## **Stage 1 Road Safety Audit**

**Firlough Wind Farm & Hydrogen Production Facility at  
Carrowleagh Bog, nr Ballina, Co Mayo**

**June 2023**

#### 4.1.6 Roundabout Central Island – Signage (2)

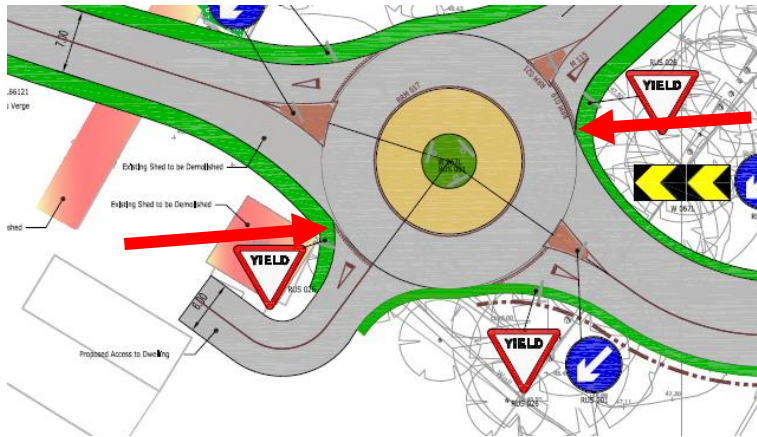
**Problem:** There are only 3 sets of chevron/Turn Left signs proposed for the roundabout central island, but the roundabout has 4 entry arms. The signage should face each entry arm.

**Hazard:** Users approaching the roundabout may have insufficient advanced warning to comprehend the junction type. Overshoot collisions may result.

**Recommendation:** Provide signage opposite each entry arm.

### 4.2.1 Roundabout Central Island – Road markings

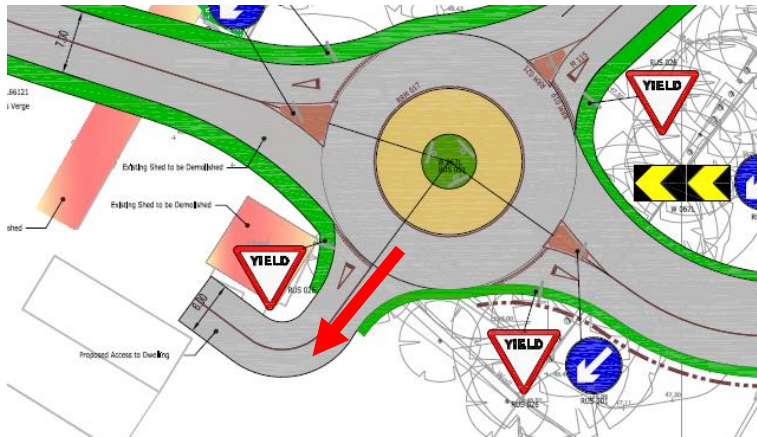
**Problem:** Incorrect road markings are indicated for the perimeter of the central island. The RRM 017 is a 200mm wide solid line. Road markings generally have less skid resistance than the road surfacing material.

**Hazard:** Powered two wheeled vehicles may over-run the wide line and skid / lose control.

**Recommendation:** Replace the RRM017 with RRM001.
